UNITED STATES
NUCLEAR REGULATORY COMMISSION
WASHINGTON, D.C. 20555-0001

April 15, 1997

LICENSEE: Consumers Power Company
FACILITY: Palisades Nuclear Plant
SUBJECT: MEETING WITH CONSUMERS POWER COMPANY TO DISCUSS REACTOR VESSEL
FLUENCE EVALUATION

Comparison of <M/C> Measurement-to-Calculation Bias Based on Fe-54 and Ni-58 In-Vessel Capsules for Palisades, Ginna and Kewaunee

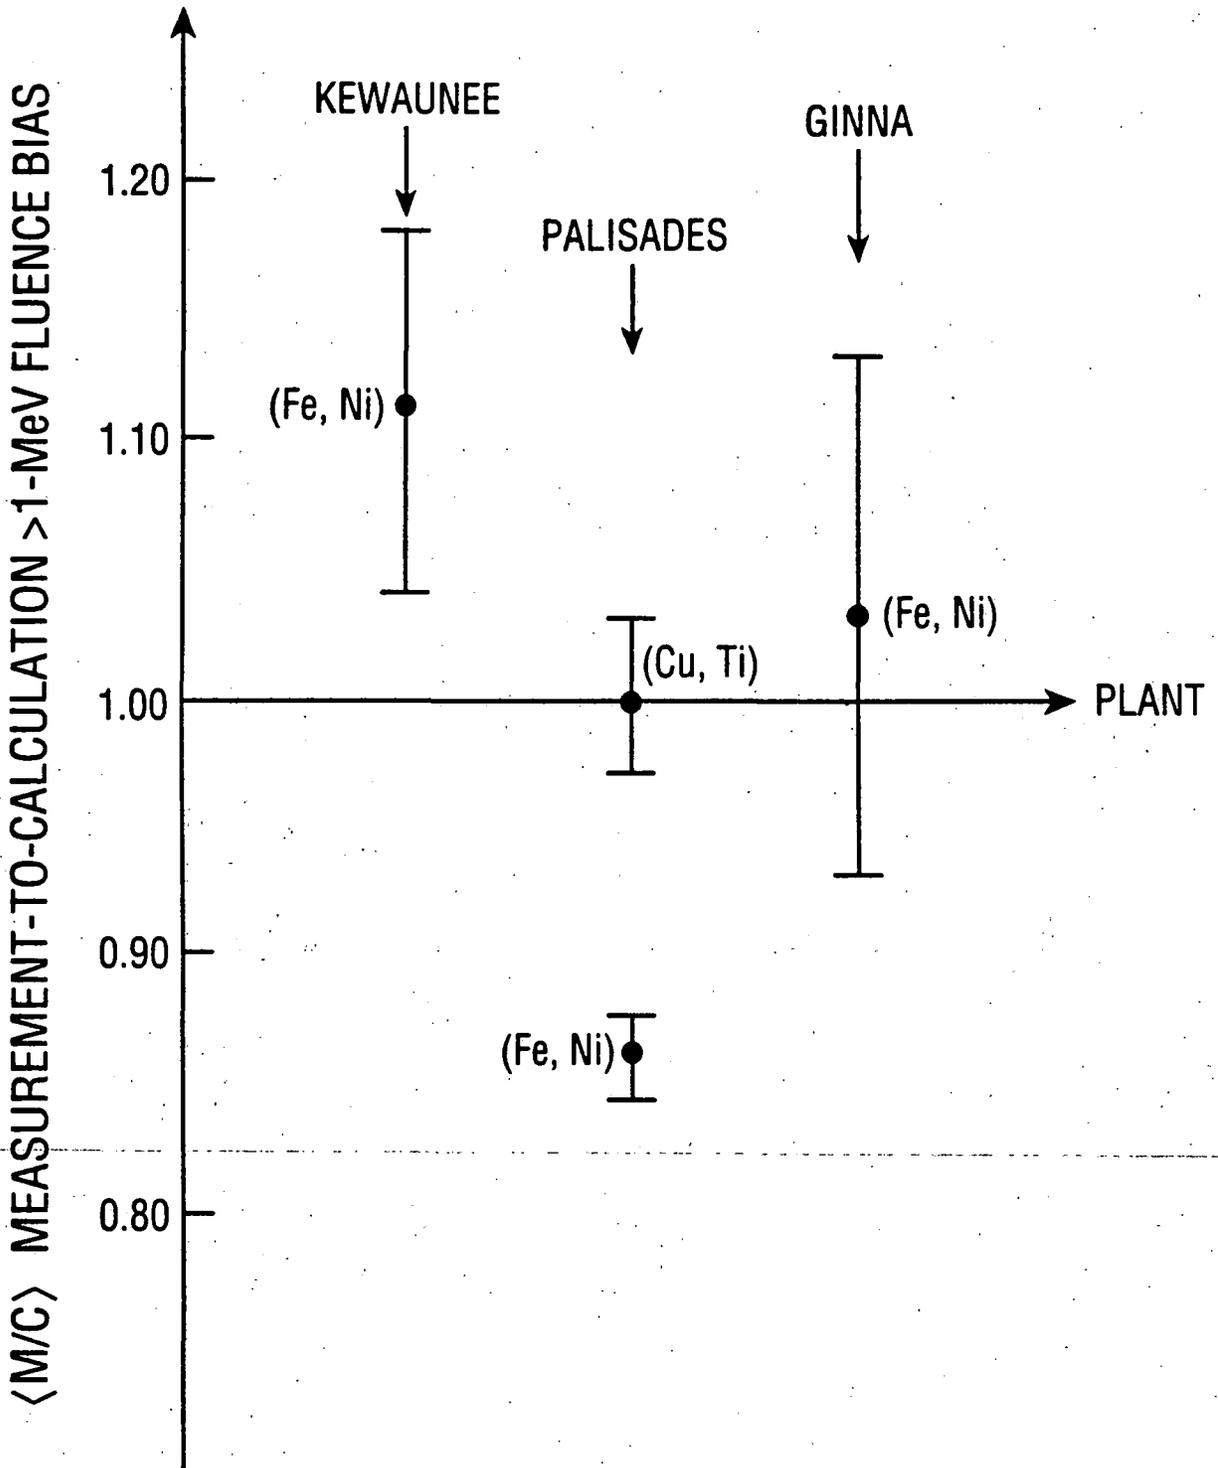
The BNL contractor discussed the differences between the Palisades dosimetry bias values and bias values derived for the Kewaunee and Ginna facilities using the same methodology. The iron and nickel dosimeter values for the other facilities exhibited significant variation in bias mean value and standard deviation, and the derived bias values for the facilities were in relatively good agreement with each other considering uncertainties. The Palisades dosimetry bias values showed relatively little variation in mean value and standard deviation, and the derived bias value did not correlate well with the values derived for the other facilities.

THE SAME METHOD YIELDS
DIFFERENT RESULTS FOR DIFFERENT
PLANTS. SPECIFICALLY: KEWAUNEE
AND GINNA (for $E > 1.0$ MeV)
M/C = 1.13 and 1.03 RESPECTIVELY
